***Somersby Drill Mud and Oily Water Recycling Facility (SSD-62863964) (Central Coast)134  
Somersby Falls Rd SOMERSBY) – Council Submission***

**Figure 1** – Proposed layout and location of aboveground tank to be installed outdoors on the northern side of the building

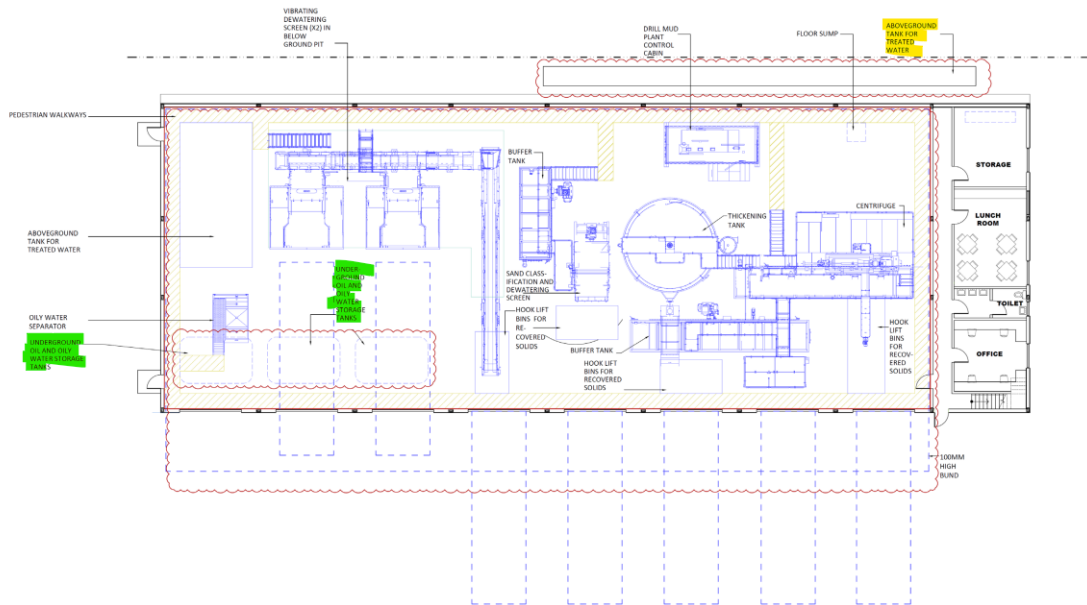
Due to the significant volume of water to be recovered from the drill mud and oily water recycling processes, there is insufficient space within the building for all temporary water storage. Consequently, water recovered from the drill mud recycling process is proposed to be stored within a custom-built aboveground tank to be installed outdoors on the northern side of the building. The tank will be internally bunded to provide spill protection. Highlighted in yellow in Figure 1 below.

The incoming oily water and the recovered oil is proposed to be temporarily held within tanks that comply with *AS4897-2008 The design, installation and operation of underground petroleum storage systems*. The proposed tanks are constructed from fibreglass to provide protection against corrosion of the tank. The tanks are double-walled and constructed to allow continuous monitoring of the integrity of the internal and external walls and leak detection (tanks highlighted in green in Figure 1 above). Standard conditions will be recommended.
